Code Compliance Certificate

Street Address	282 Te Moana Road, Waikanae
Valuation No.	1493133400
Legal Description	LOT 47 DP 18250 CT 716/16
Intended Use	Residential
Intended Life	Indefinite, but not less than 50 years
Current Use	Residential
Proposal	New Carport
Estimated Value	\$4,000

Building consent 060749

Description: New Carport
Location: 282 Te Moana Road, Waikanae
Legal Description: LOT 47 DP 18250 CT 716/16

SHS INTO FOOTING DETAIL
REVISED JUNE 03

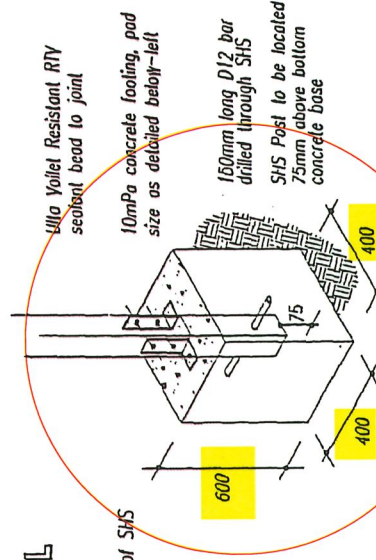
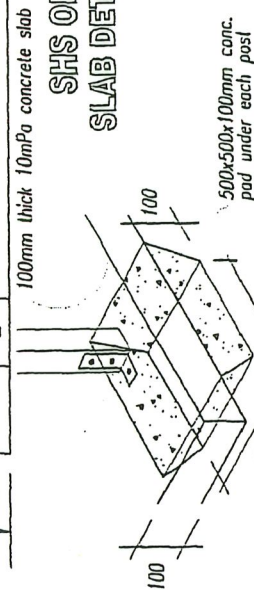
- Require angle brackets
to be fixed from post
into foot as per spec

Revised detail
submitted 25/10/06
ok to issue c.c.c

DRAWING TITLE: Elevations & Cross Sections

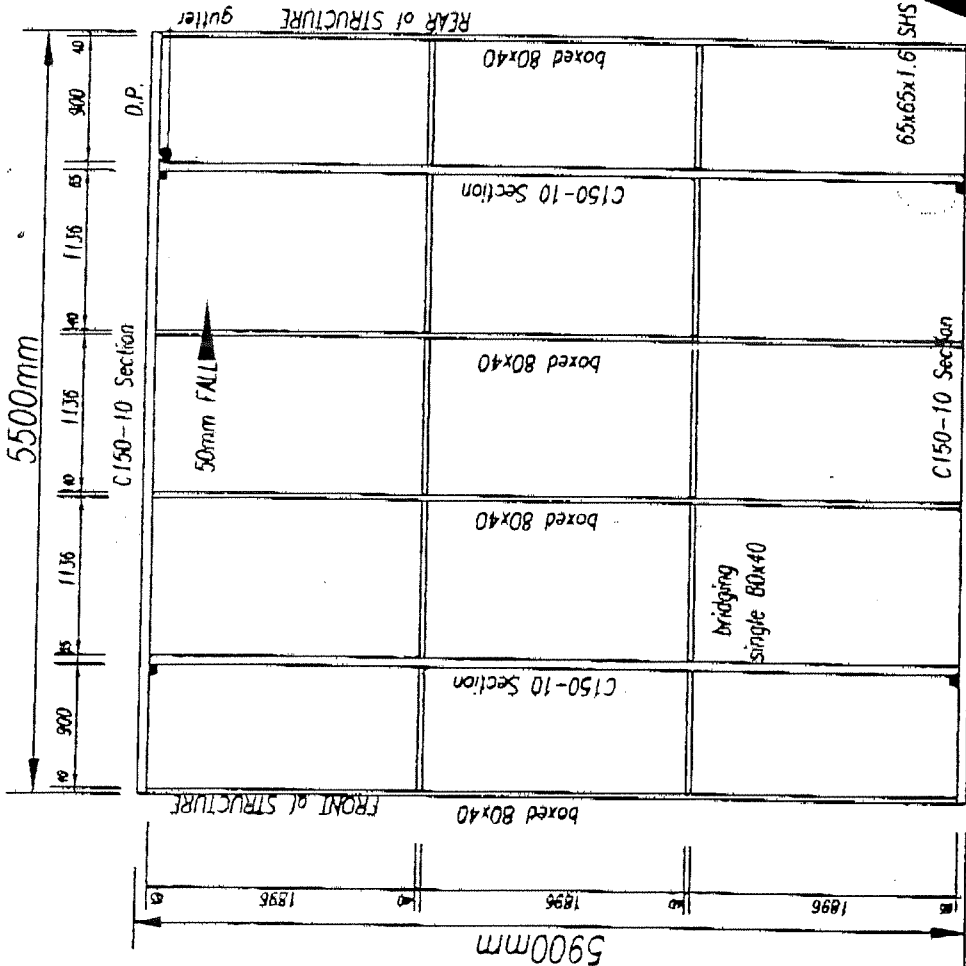
On the plans submitted to Council for BC060749P, there are no height measurements nor is there an access plane which could be interpreted to be the height in relation to boundary line.

Please send a plan into Council showing both the height of the proposed car port and the height in relation to boundary recession plane drawn in, along with relevant scales for each drawing.

Figure 17B: Level thresholds for ground level
Paragraphs 7.3, 7.3.2, 7.3.2.1 and 7.3.2.2

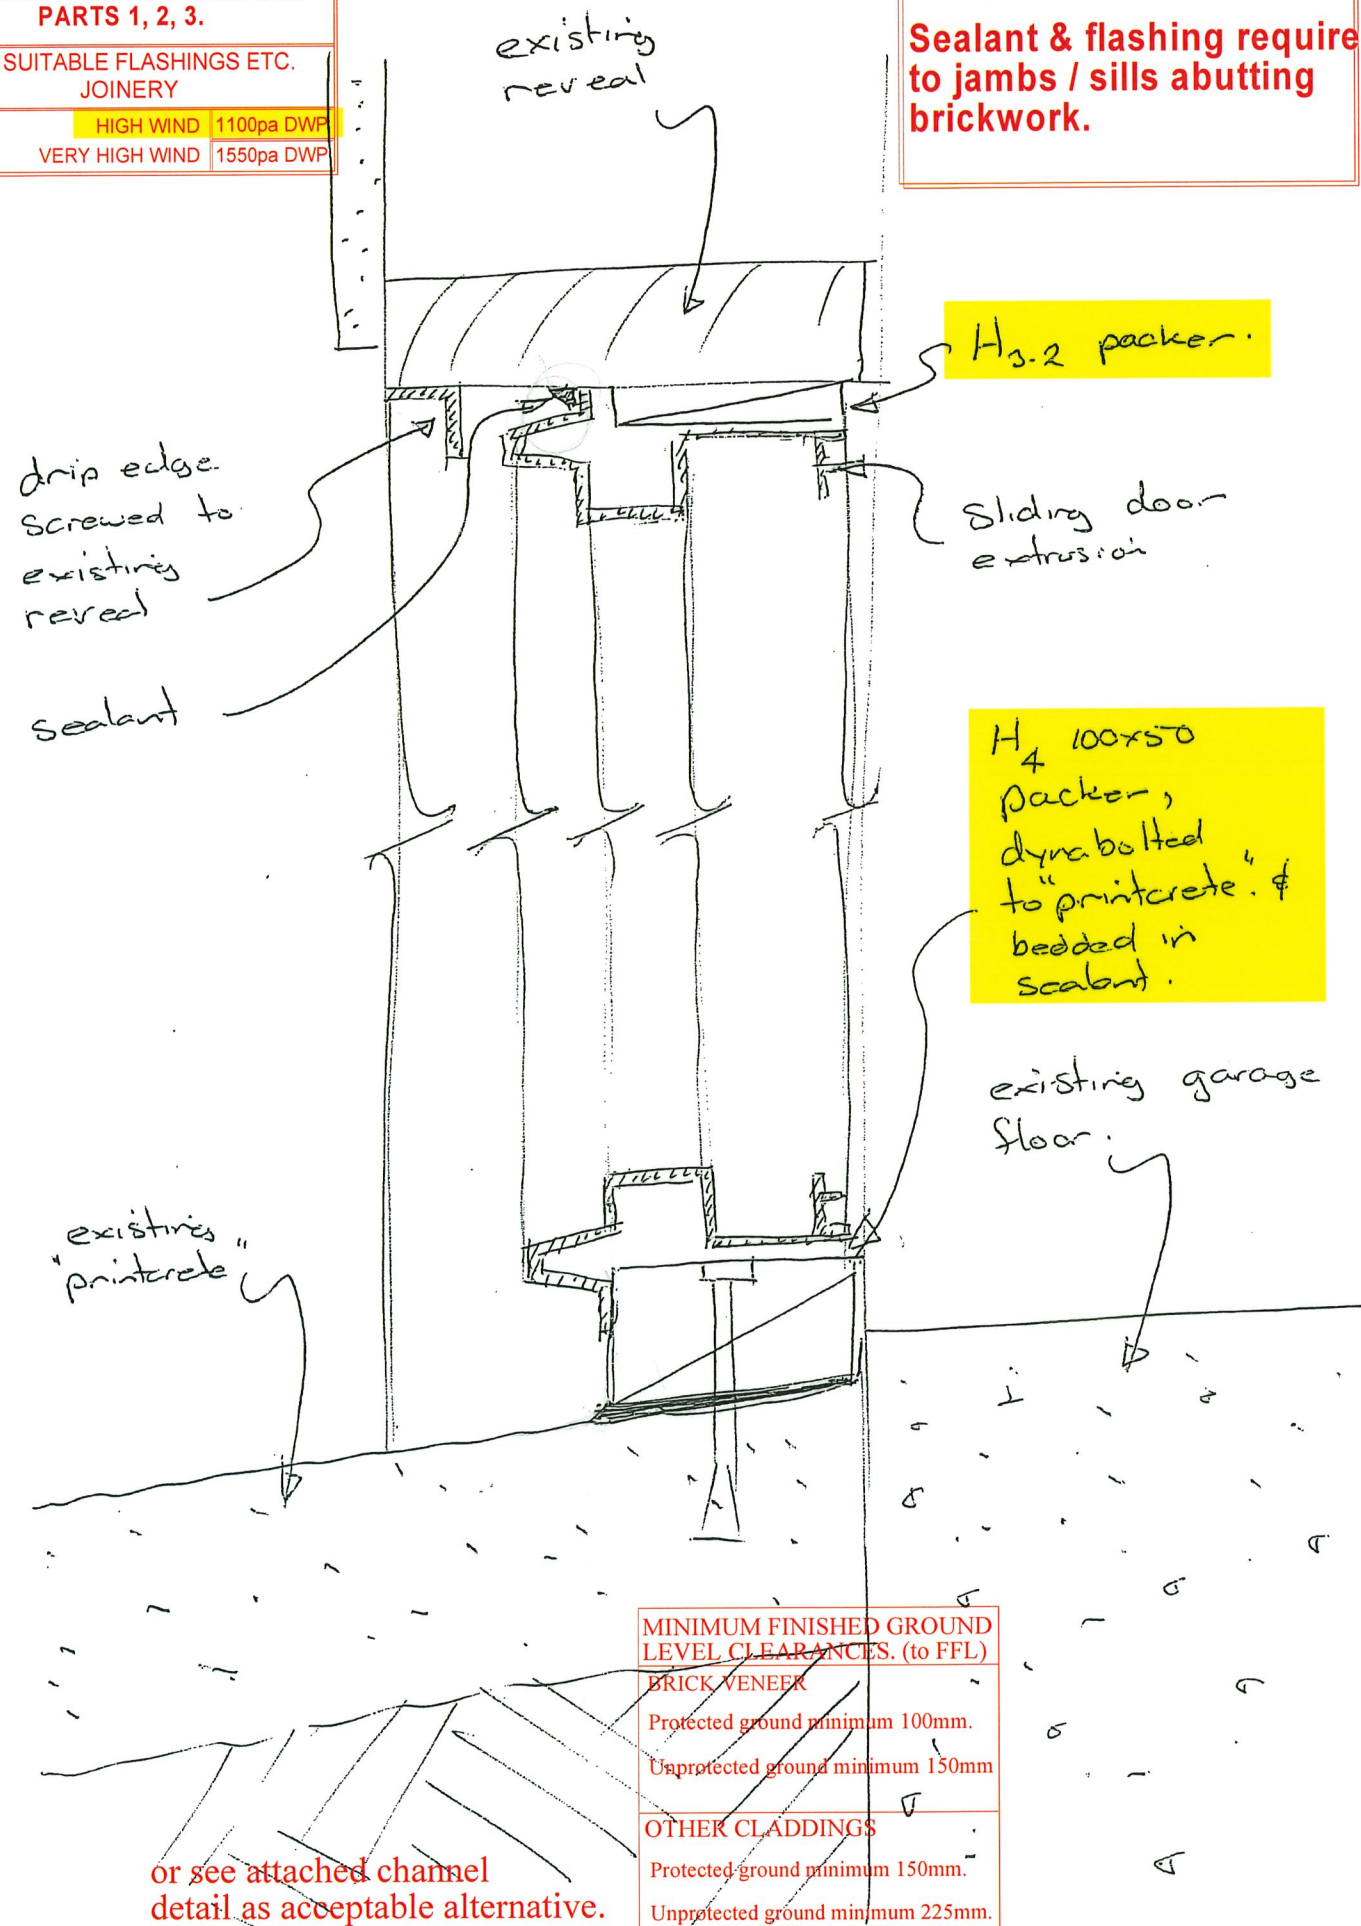
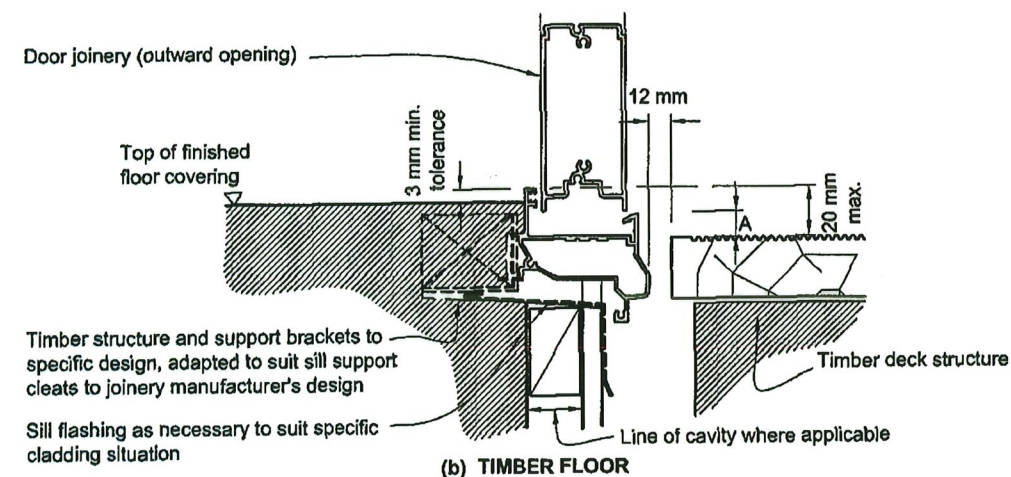
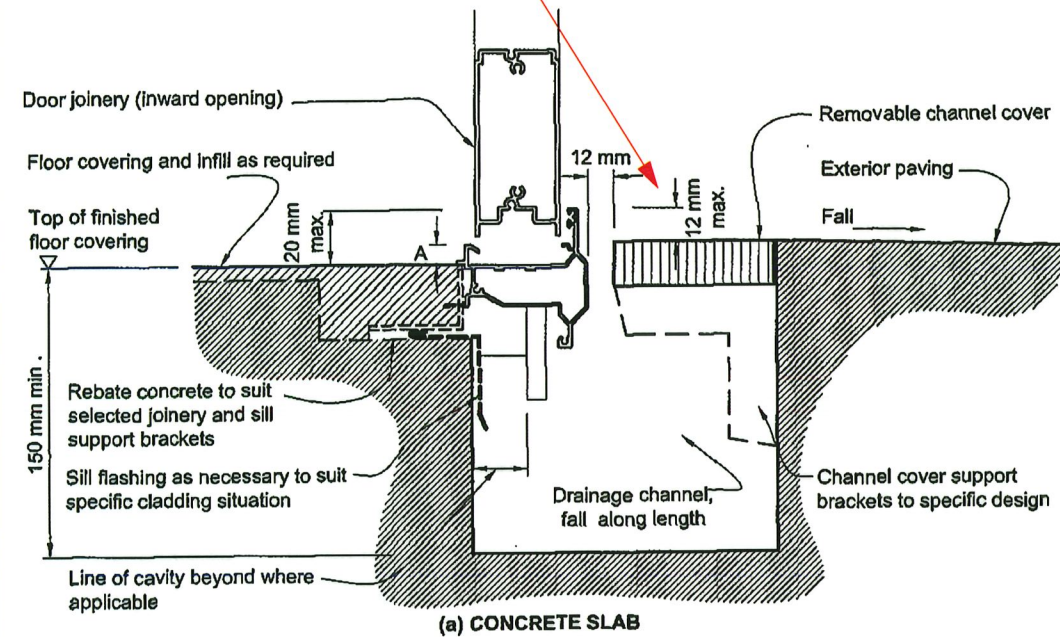
Sealant & flashing required
to jambs / sills abutting
brickwork.

Recommend this detail for door

1. No post wrap inspection was carried out because there is no wrap and no cladding. The doors were installed between existing door jambs.
2. I confirm that the 2 doors were built to 'High Wind Zone' requirements. ✓
3. The new sliders are sitting on treated timber bedded in sealant, as per the drawings submitted in the building consent and shown to Ken Smith prior to building consent application.
4. There is no head flashing. The drawing shows a drip edge under the existing jamb (also shown to Ken Smith).
5. What framing do you mean?

Please note - Ken Smith has
seen this drawing & is happy
with the sealant under sill. Packer,
but wants to know more about any flooding
history. The owner has since visited the site in
heavy rain & noticed that the drive way
drains to lower areas naturally (See drawing)
